Bulletin: 57-18

TO: All Greenheck Representatives
FROM: Bethany Seubert
Product Manager, DOAS
DATE: November 27, 2018
SUBJECT: Models RV-110 & RVE-180 Replace Model APEX

Model RV-110

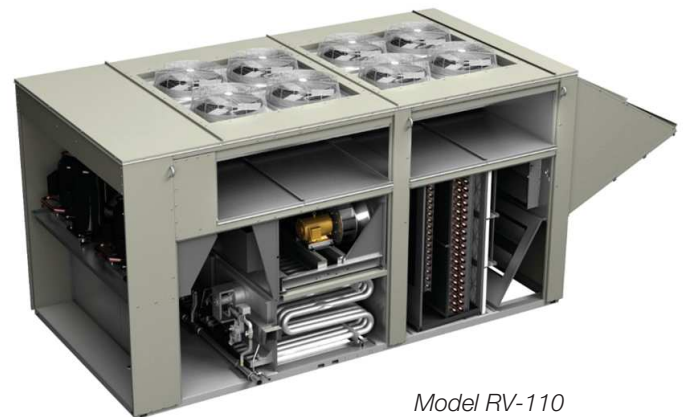
We are committed to providing you with more competitive products and expanding capacities and features with our dedicated outside air units. In the December CAPS® 4.28 release, we will offer the new RV-110 and RVE-180 housings, expanding models RV and RVE up to 70 tons of cooling capacity and up to 18,000 cfm of outside air volume. The RV-110 and RVE-180 will be available with packaged DX or chilled water for cooling options and indirect gas-fired furnace, electric heat, or hot water for heating options.

The new RV-110 and RVE-180 will provide more competitive models with expanded tempering options and additional standard features such as 2 inch R13 foam construction and VFD driven direct drive plenum fans. These new RV and RVE housings will have a 10:1 turndown furnace with indirect gas-fired heat selected and a digital scroll compressor with packaged DX cooling for precise temperature and humidity control.
